VALUE ENGINEERING STUDY

Project # CSSTP-0009-00(396)

Project # CSSTP-0009-00(397)

Atlanta Beltline Southwest and Southeast Corridors Fulton County, Georgia

PROPOSAL NUMBER: T6-2

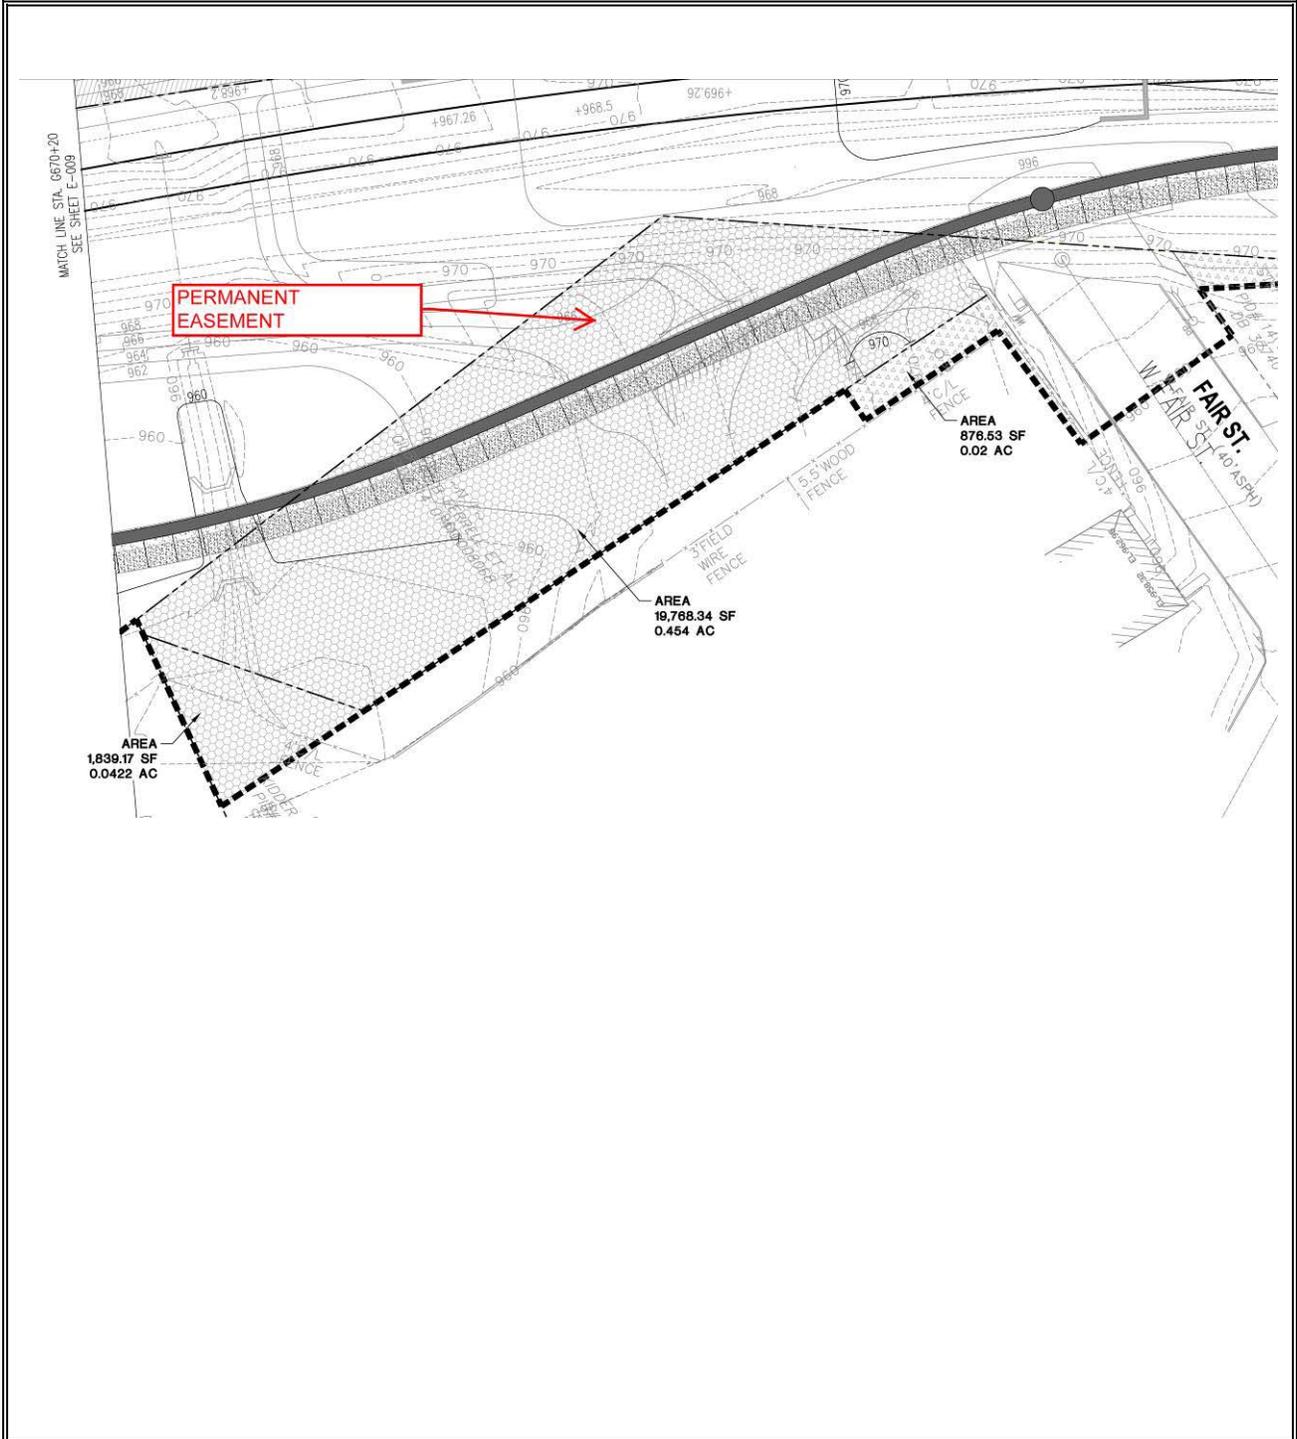
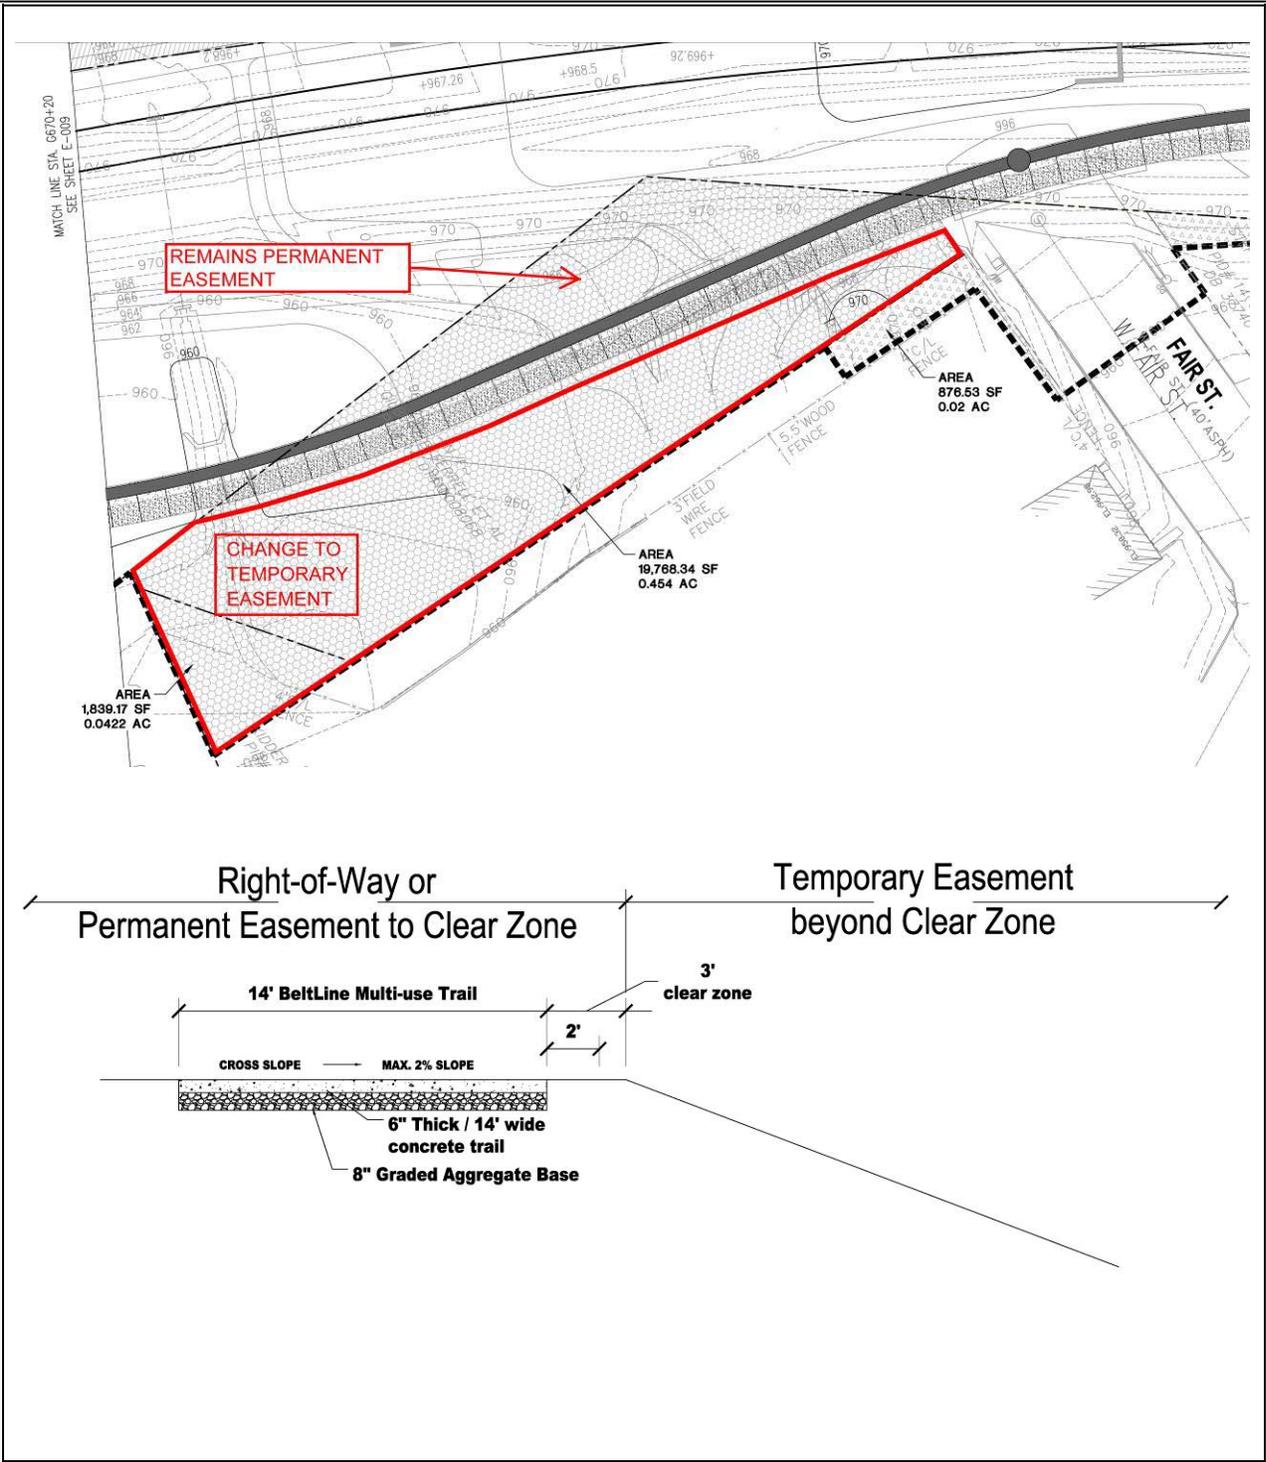
PROPOSED CHANGE: In areas where cut or fill slopes are to be implemented, it is proposed to utilize a permanent easement to the clear zone (3-foot from trail edge). Utilize temporary easements to accommodate the remainder of the limit of work area beyond these permanent easements.

1. STA G670+20 to STA G673+50 at Fair Street [Sheet E-010]
2. STA G725+30 to STA G727+00 [Sheet E-019]
3. STA G745+80 to STA G747+90 [Sheet E-023]

PROPOSAL NUMBER: T6-3

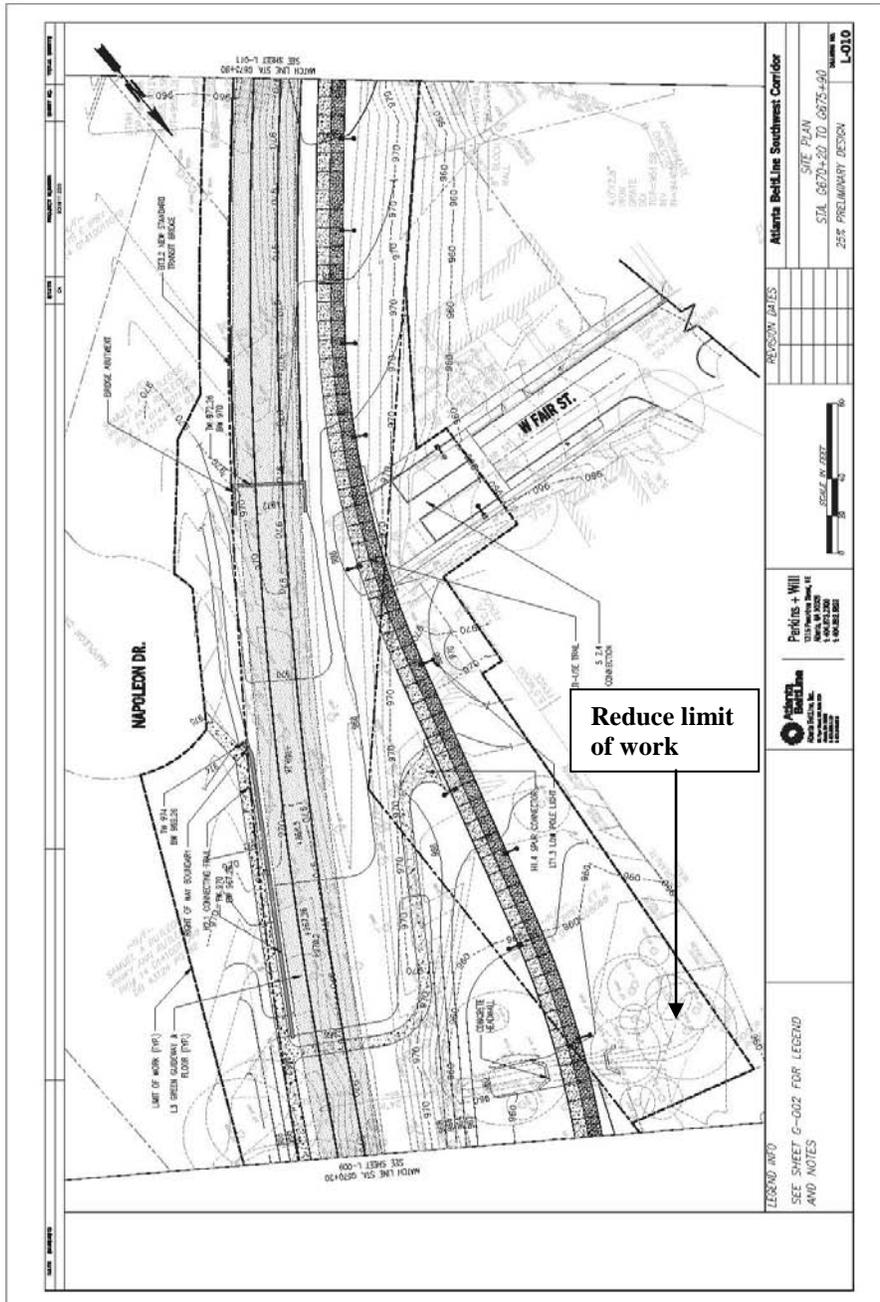
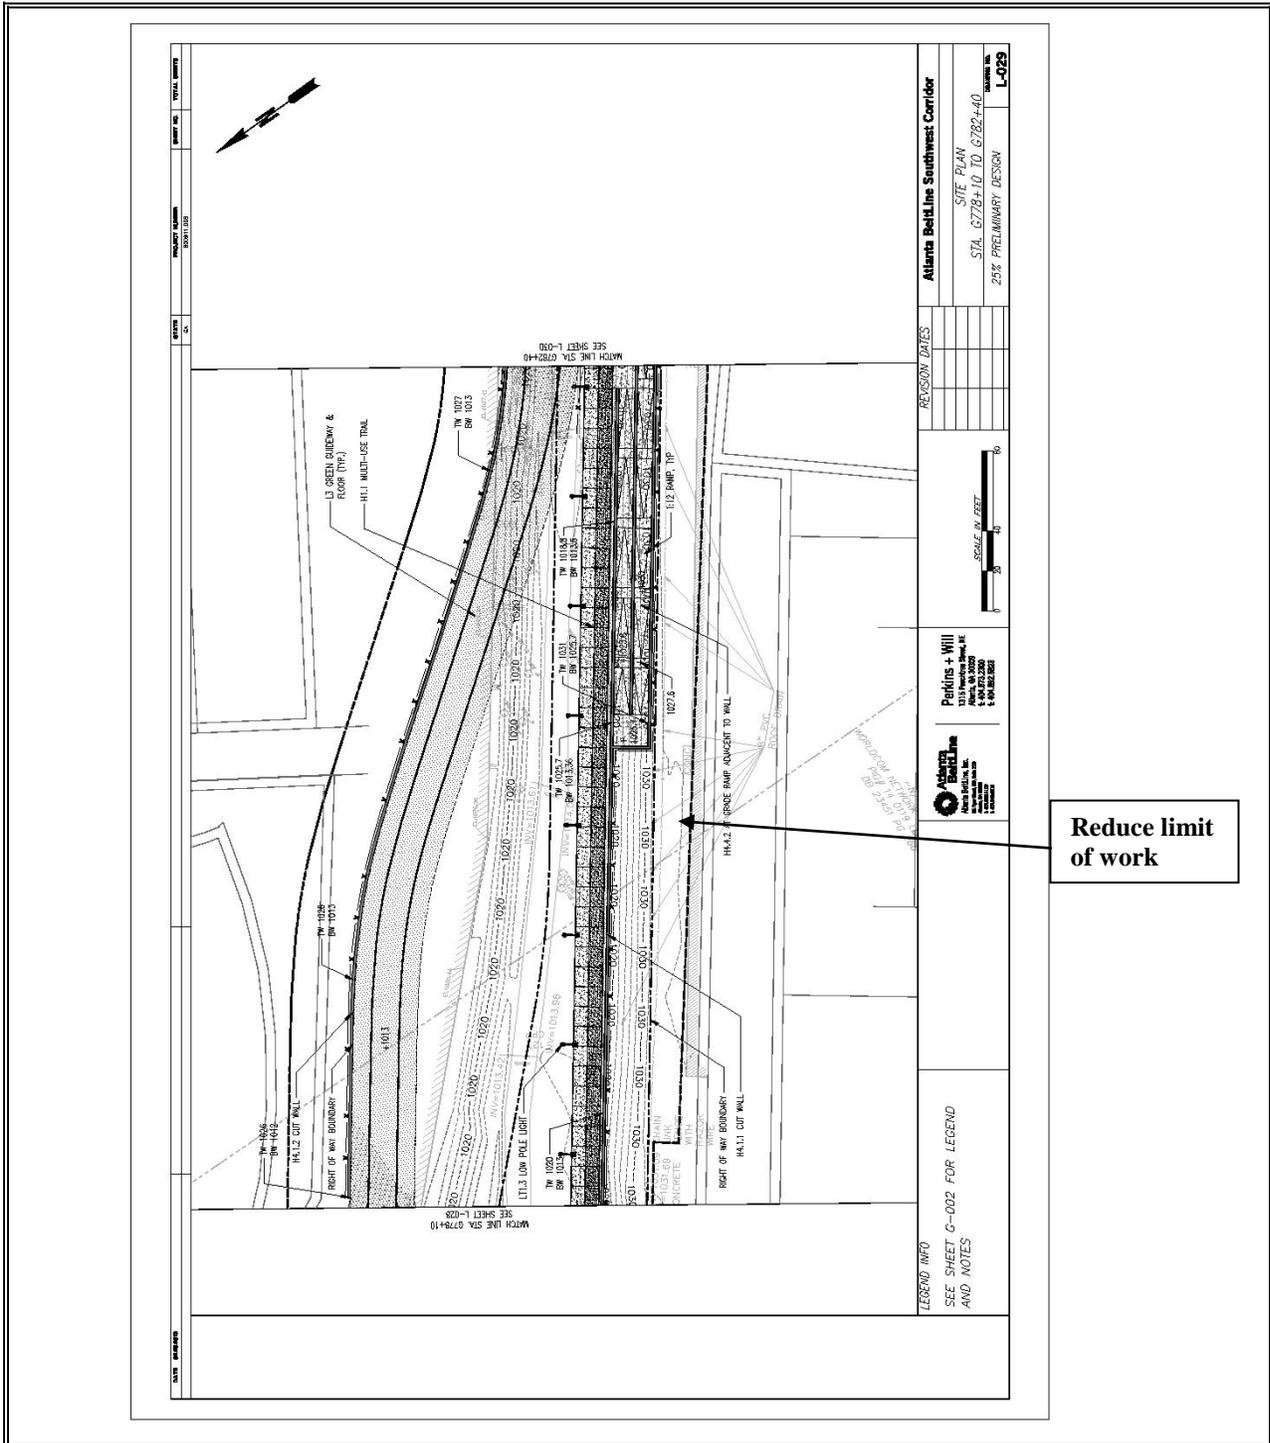
PROPOSED CHANGE: It is proposed to reduce the limit of work to the area of grading and reduce unnecessary easements to be acquired outside of right of way. As identified in the calculations sheets within this proposal, there are 4 locations where this proposed alternative can be implemented.

JUSTIFICATION: In one area North of W. Fair Street, easement was obtained to provide additional landscaping which can be removed since it is not required to construct the trail. In the other areas, with an example being West of Lee Street, the limits extend outside of right of way behind walls where it can be reduced to a point approximately 20' behind the wall.

PROPOSAL NUMBER: T6-4

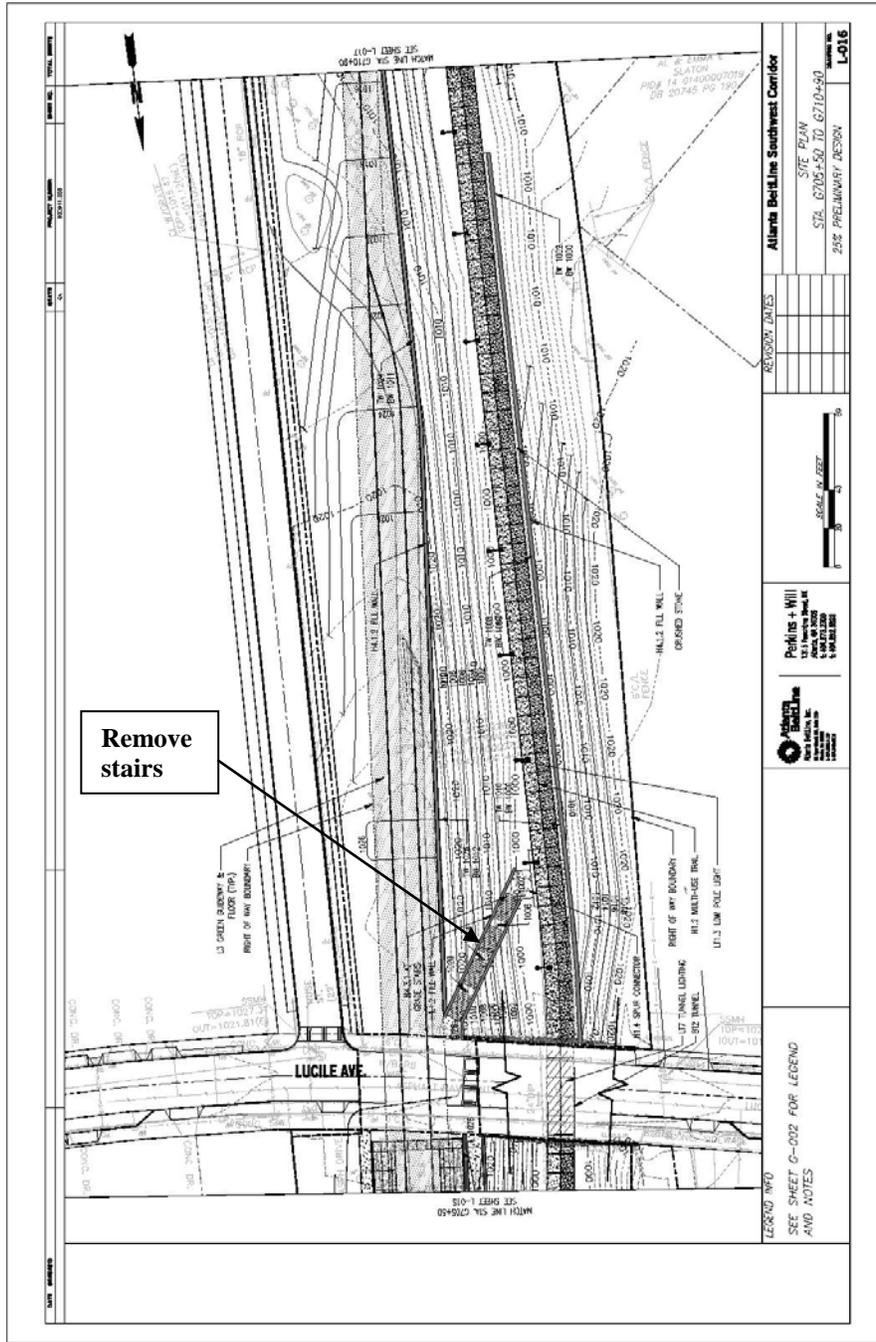
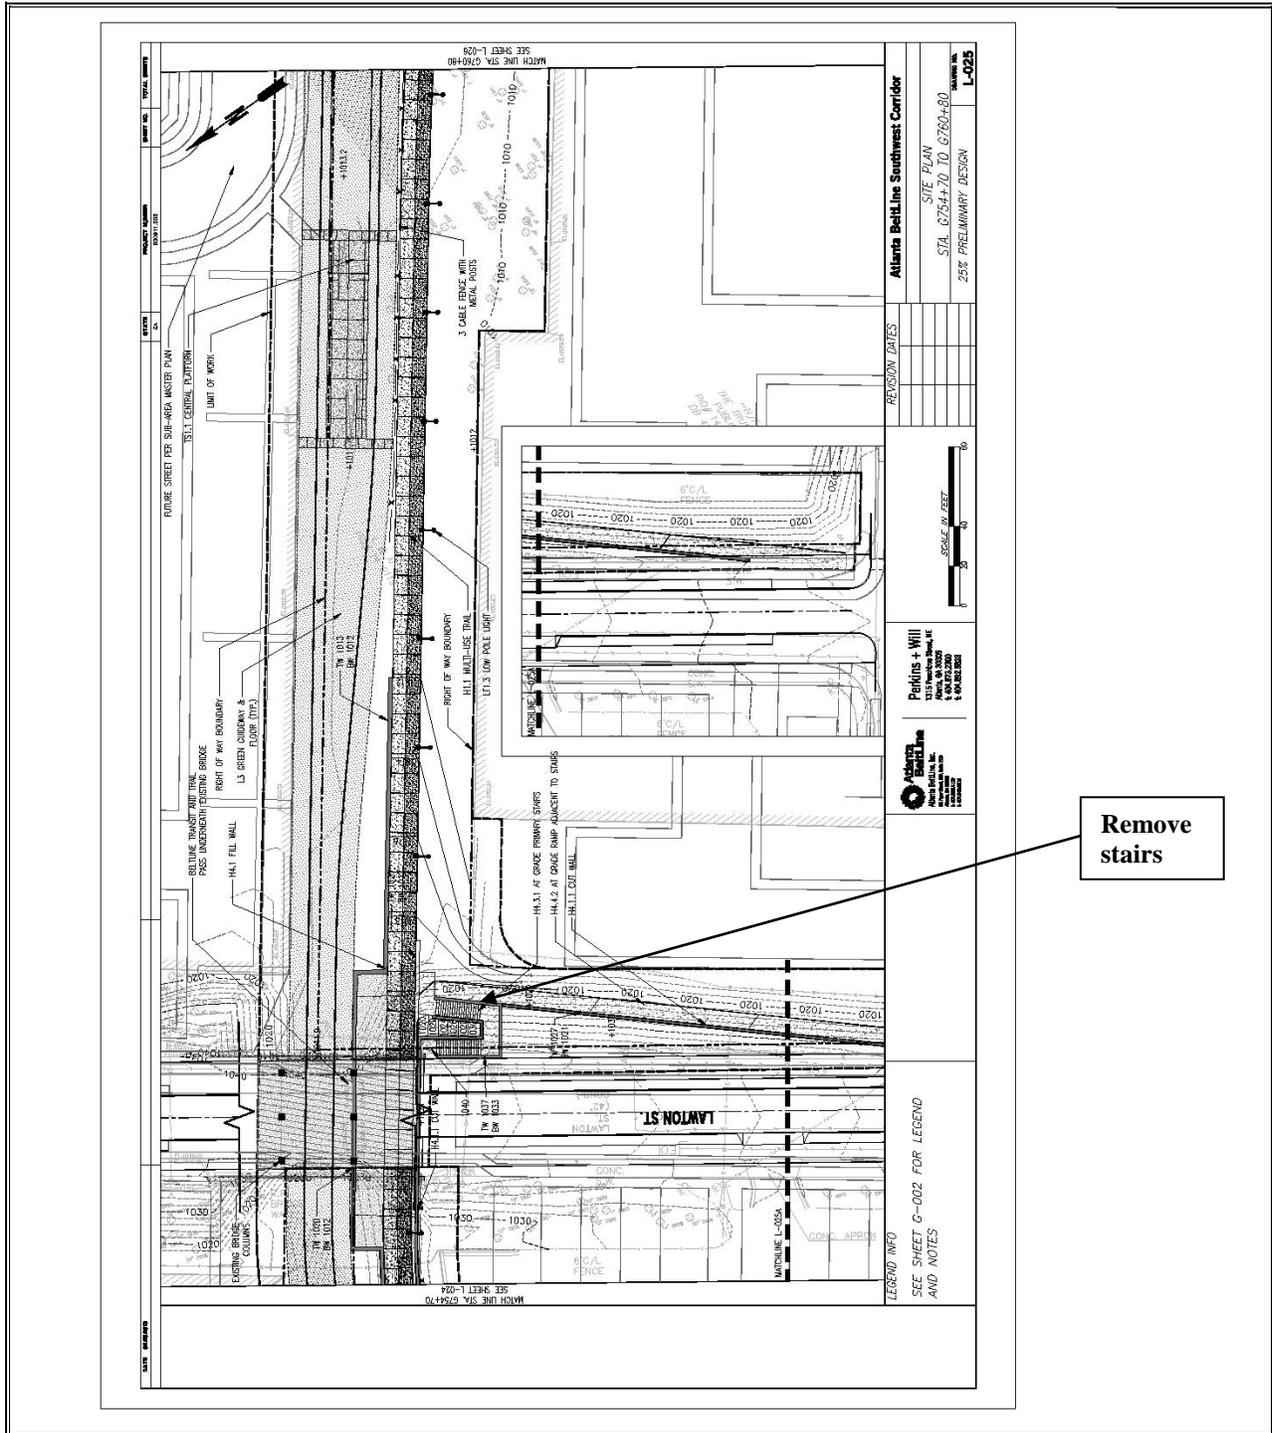
PROPOSED CHANGE: It is proposed to eliminate stair access and allow all users to enter trail via ramps.

JUSTIFICATION: The purpose of the stairs and ramps is to provide access to the trail. One access point for each location where access is needed will be adequate to serve the trail. Therefore, removing the stairs is possible since the ramp is required to meet ADA standards.
